VARIANCE REQUEST

Iowa Department of Natural Resources

RE: Charles City Wastewater Treatment Improvements - Variance Requests

Re: Charles City WPCP Improvements
Charles City, IA
FOX PN 2389-00A.410

FIGURE 6-42

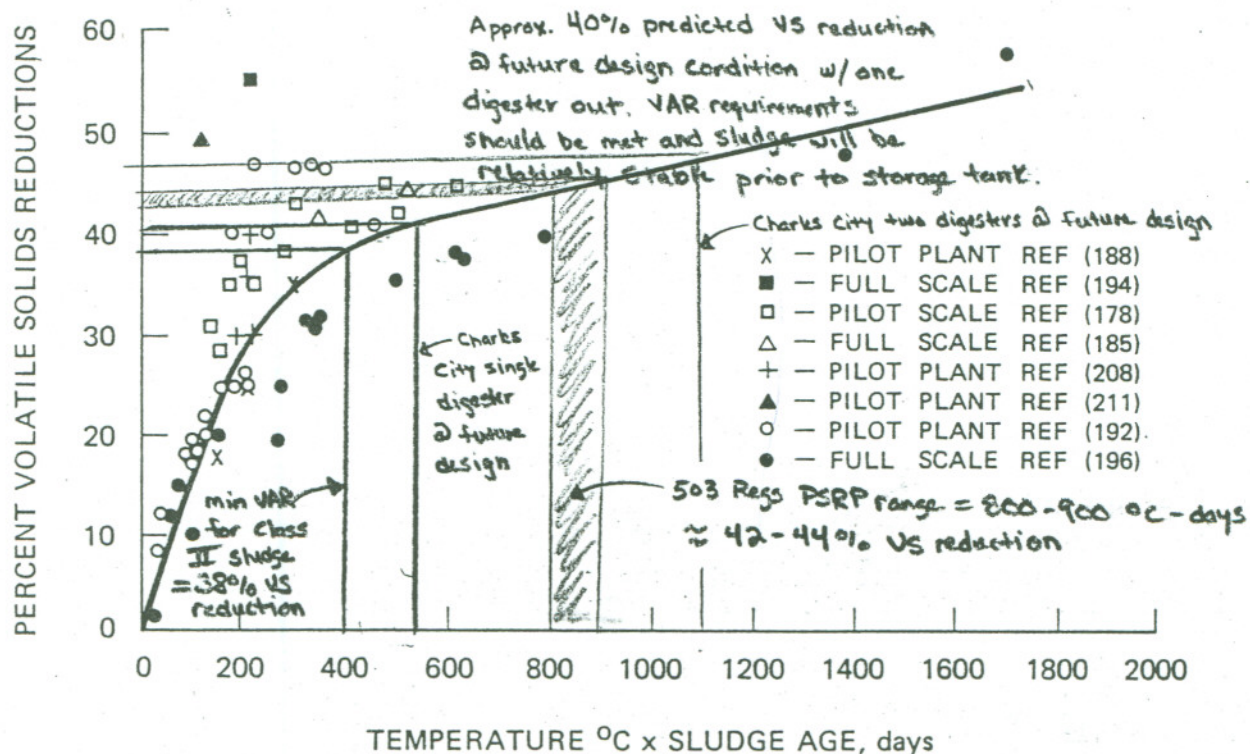
As for vector attraction reduction (VAR) requirements, we believe the requirement of 38% volatile solids reduction (VSR) can be achieved with one digester out of service. Research suggests that VSR efficiencies can be plotted as a function of the product of SRT (days) and temperature (°C) and used to predict digester performance. A typical plot of this nature, based on research data,

predicts under current conditions (803 deg. C-days) a VSR of about 44%. Actual VSR, using the Van Kleck Method, is about 57%. At design conditions with one digester out of service, the predicted VSR (at 563 deg. C-days) is about 41%. Even at 26° C, predicted VSR is about 40%. Based on this data, we believe the 38% VSR requirement can be met with one digester out of service. However, even if the 38% VSR requirement is not met, the City does own land application equipment with the capability of injecting.
